## Modification Assessment Report MOD 7531

Modification (2) of DA 6968 – alignment of fibre  
optical cable and infrastructure

Modification to the approved subdivision and  
telecommunications facility at the Cat Shed,  
Thredbo Alpine Resort, Kosciuszko National  
Park

Secretary's Environmental Assessment Report  
Section 96(1A) of the  
*Environmental Planning and Assessment Act 1979*

**Figure 2:** Revised alignment of cable from the approved tower to Telstra pit on opposite side of Thredbo River (Source: Applicant’s MOD documentation)

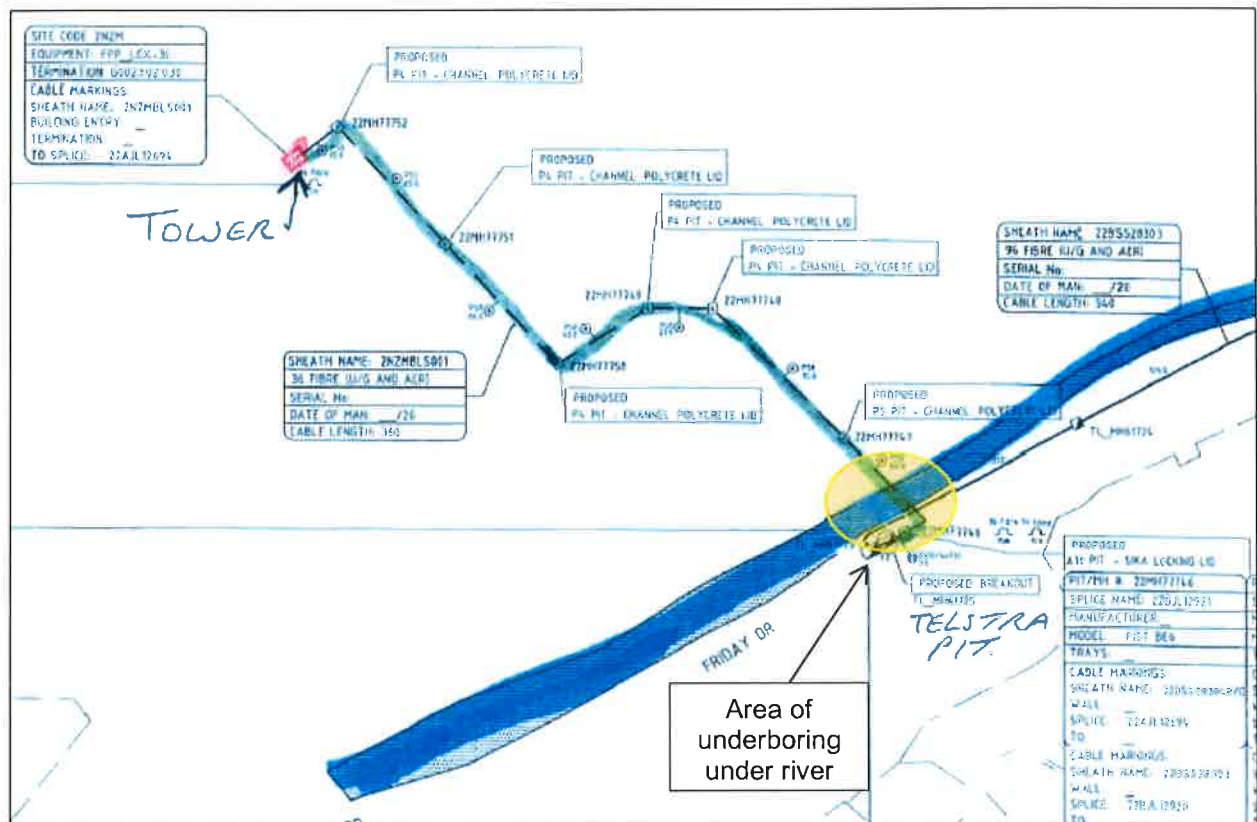
The revised alignment follows the Snowgum chair lift clearing, downhill, around the back of the chair lift terminal, around a disused tennis court and under the Thredbo River, before exiting at the Friday Drive park, where the nearest Telstra pit is located. The works also require the installation of seven telecommunication pits in order to haul the cable and for future servicing needs. The alignment and pit locations are identified on **Figure 2**.

The modification seeks to realign the fibre optical cable route (via underboring) from the approved tower location down the Snowgum chair lift clearing and along disturbed ski slopes before going under the Thredbo River.

- the proposal minimises potential environmental impacts through utilising underboring instead of digging trenches along the revised alignment; and

- disturbance above ground level is minimised by the construction of only installing seven new pits to service the fibre optical cable.

The Department is satisfied that the proposal is appropriate and the Applicant has adequately considered its impact upon the natural environment by providing the revised alignment through previously disturbed ski slopes. Where the works disturb the existing ground level (introduction of the pits), the Department notes that the exhumed material will be backfilled around the pit and then the ground levelled.

**Figure 3:** Illustration of underbore technique beneath Thredbo River (Source: Applicant's MOD documentation)

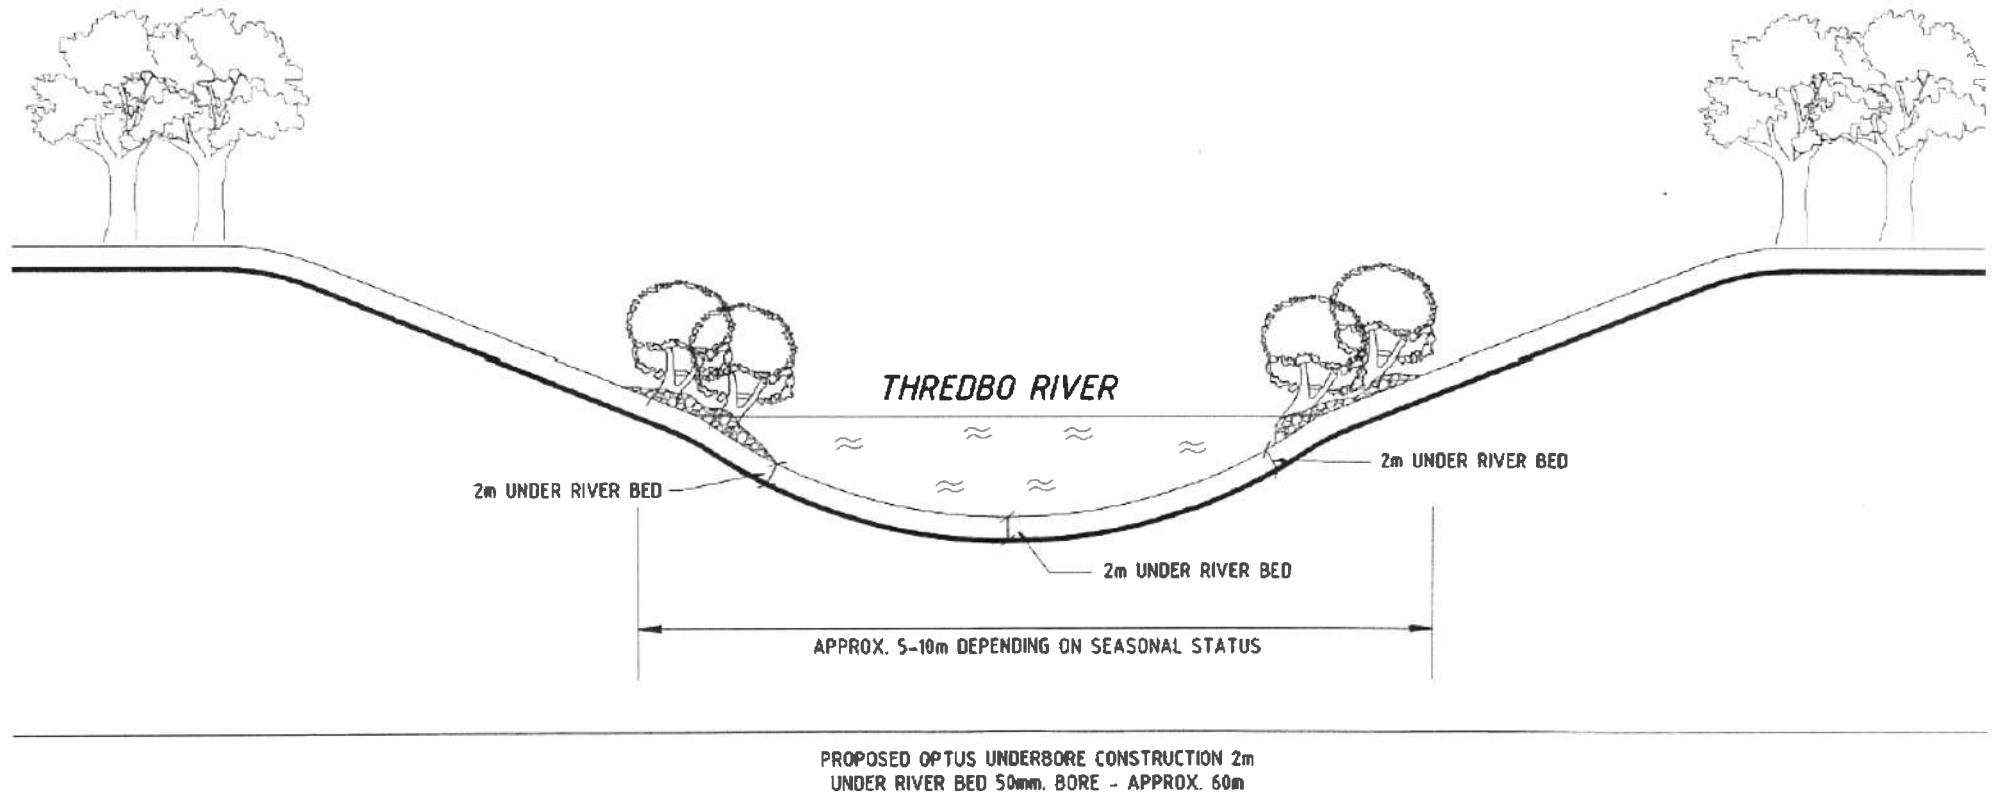
Works are to be carried out on disturbed ski slope and no trees / shrubs are proposed to be removed as a result of the proposed works. The underboring is proposed to be undertaken 1.6 metres below the surface, except for under the Thredbo River where it is proposed to be a minimum of 2 metres below the river bed (**Figure 3**).

Comments received from the OEH, questioned whether a contingency plan should be provided to address events such as when sub-surface rocks are encountered during the works. The Applicant has provided further information in relation to the type of drill to be used and also options should sub-surface rocks be encountered and the drill is unable to drill through the rock. The information provided is considered to be acceptable and enables the Department to progress the application.

The proposal still remains substantial the same as originally approved and there will be minimal environmental impact as a result of the realignment. The NSW Office of Water has requested that the Applicant obtain a CAA for the underboring of the Thredbo River prior to commencement of works. No new Section 79C(1) matters are raised as a result of the amended alignment than originally considered.
